Information Bulletin No. 019T.7.58.002 I

Inspection of the tow release

control system

Type: LAK-19T

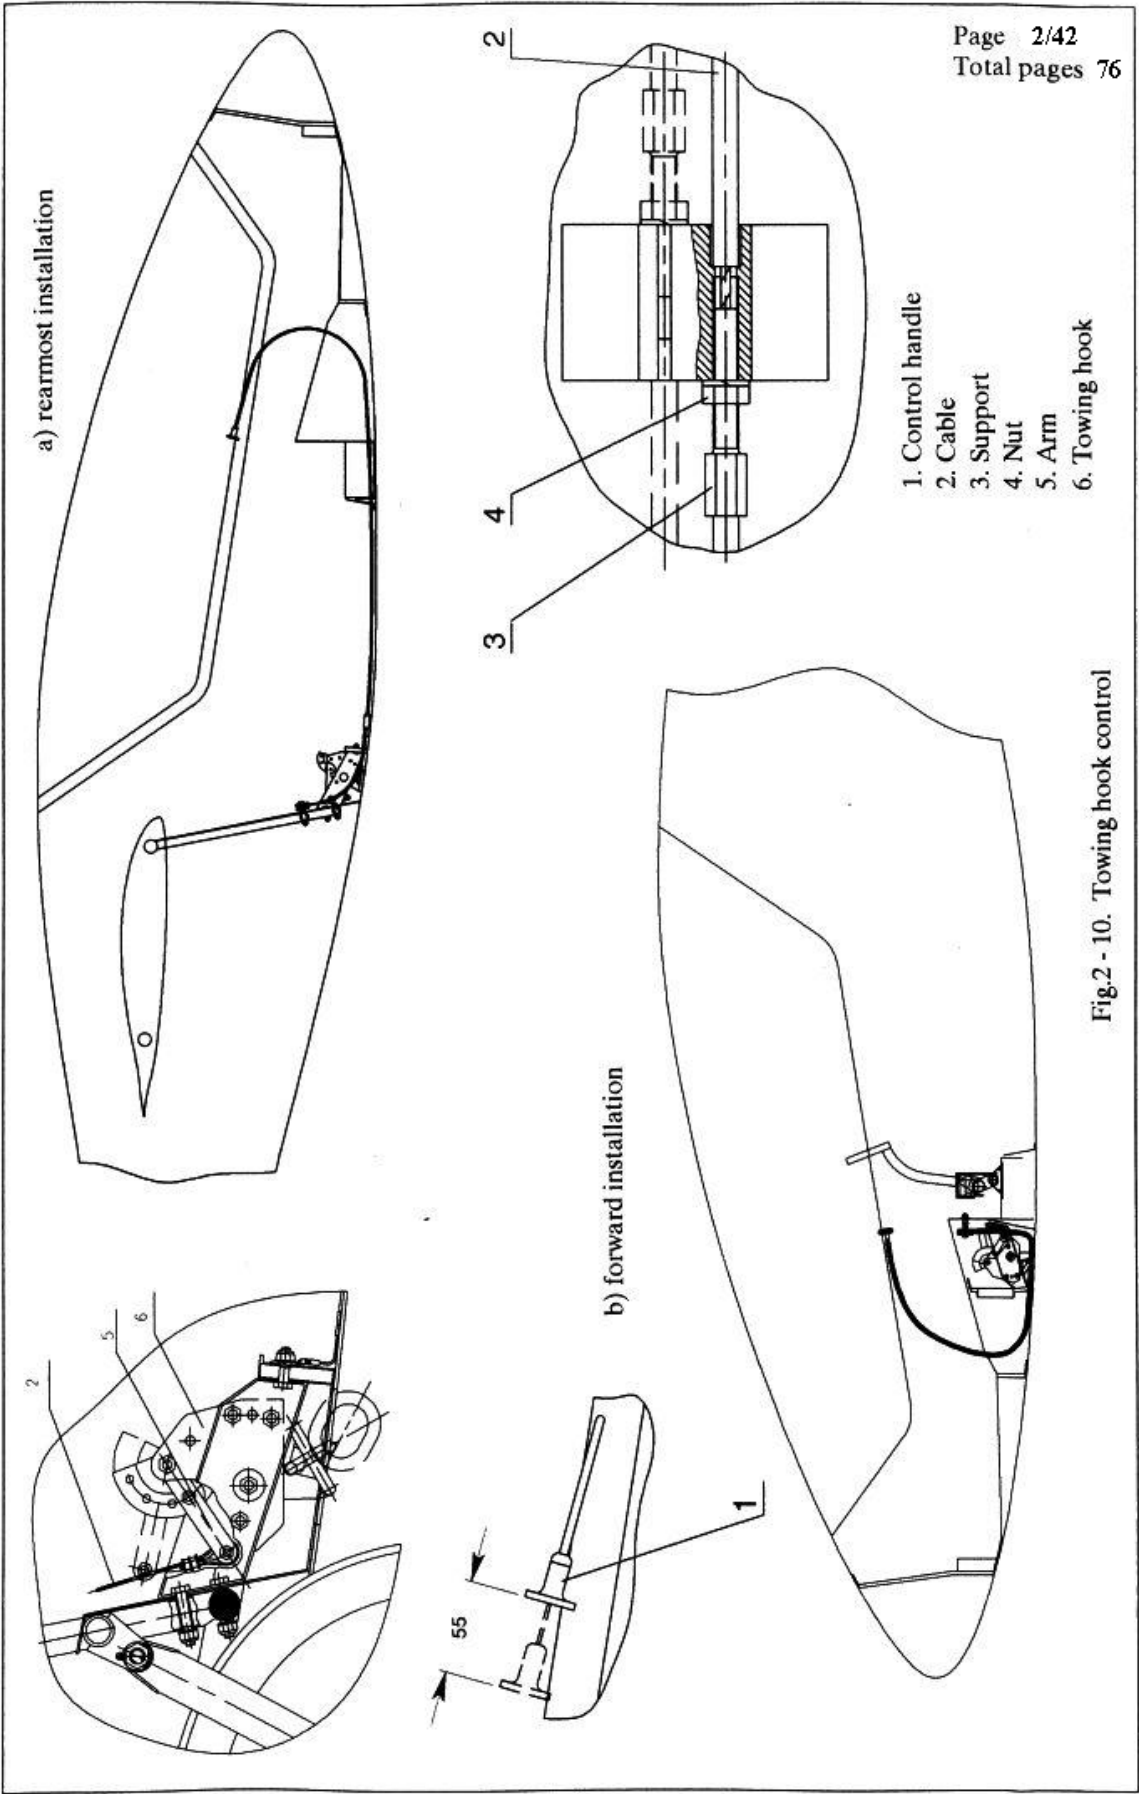
3. Reason: The tow release mechanism was rubbing against the top of the covers on gliders LAK-17AT S/N 182 and S/N 188.

If motion of the handle is less 55 mm you must removed the cover from towing hook, arranged in central part of fuselage at the main frame and chech motion of the tow release handle. If motion of the handle is 55 mm it signify – the release mechanism was rubbing against the top of cover. For correction it is necessary:

- a) Made a hole according photo No 1.
- b) After cutting hole it is necessary to mount cover and inspect tow release control system (see photo No 2, 3) according fig. 2-10 towing hook control.

After inspection you must hole close with glueing 3 layer glass fiber 92125 cover according Sketch No 1 or place an order for new cover.
